TE Connectivity

Product Change Notification: E-16-018032

General Product Description:	
DEUTSCH DT plug - 8 pin

Current Front seal Drawing Proposed Front Seal Change

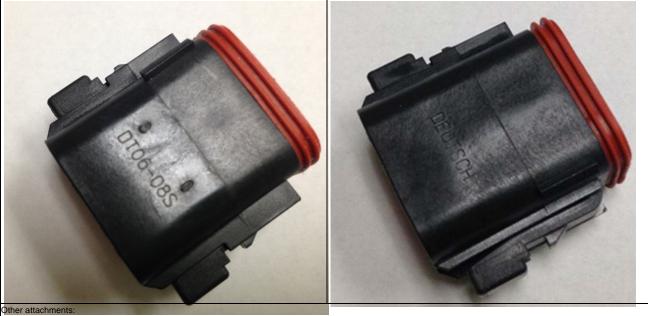
The Industrial and Commercial Transportation (ICT) business unit of TE Connectivity (TEC) intends to implement a change to the DT8 pin plug front seal (1010-007-0806) to improve sealing robustness. The inside width and length will decrease approximately 4% and 5%, respectively. Also, the amount of silicone phenyl fluid will reduce from 1.75% to 0.50%. PPAP package will be offered by customer request once a sufficient inventory bank is built to prevent any delay. DT8pin product drawings are not affected, however see attached for 1010-007-0806 pre-release product drawing.

Current Seal (Shown with DT06-08SB)

New Seal (Shown with DT06-08SB)
